July 2, 2024

RE: Rezoning Application of Maier Farms Real Estate LLC
[Rezone Petition #12058](#)

Exhibit A

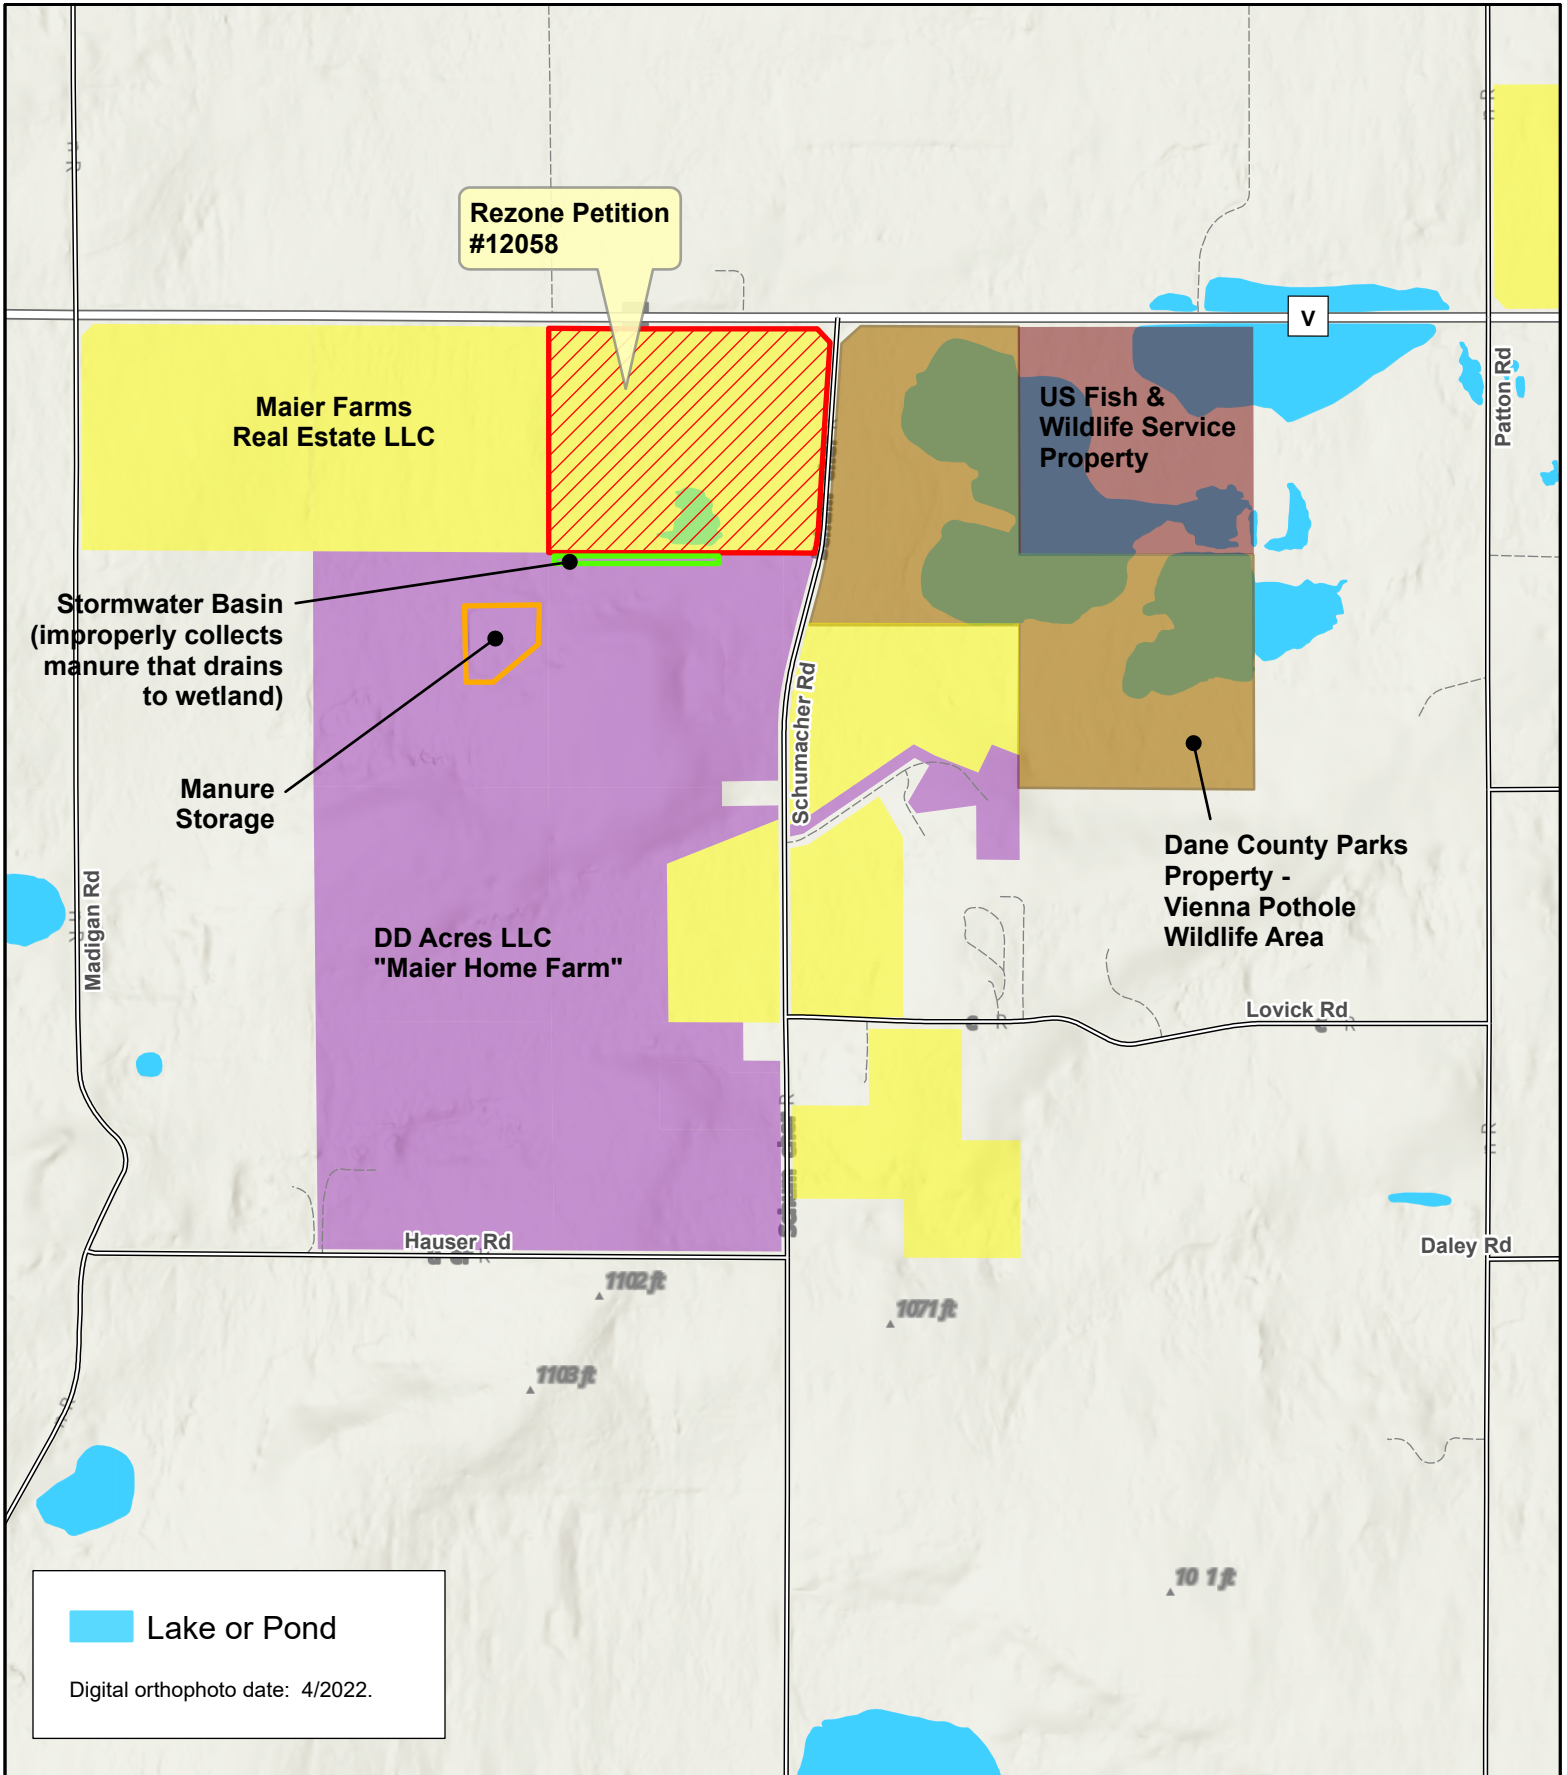
- As noted in the June 17th letter from the applicant’s attorney, the property to the south of the Maier Farms Real Estate LLC property is also owned by the Maier family as the “family farm” (the property ownership is DD Acres LLC and will be referred to as the “Maier Home Farm”). The Maier Home Farm is currently being investigated to determine potential violations of Chapters 11, 14, and 74 of the Dane County Code of Ordinances. This is relevant for two reasons: (1) it

potentially demonstrates a pattern of ordinance violations and (2) there is not an approved stormwater management plan on the Maier Home Farm property, which is negatively impacting Maier Farms Real Estate LLC property. A stormwater basin on the Maier Home Farm property improperly collects manure laden runoff that then discharges to the wetland on the Maier Farms Real Estate LLC property. The discharge of manure further compounds all of the issues identified above and the property is being investigated for protentional violation of Chapter 49: Agricultural Performance Standards and Manure Management, Dane County Code of Ordinances.

“Exhibit A” is attached to orient the committee to the various properties and to illustrate the concerns identified herein.
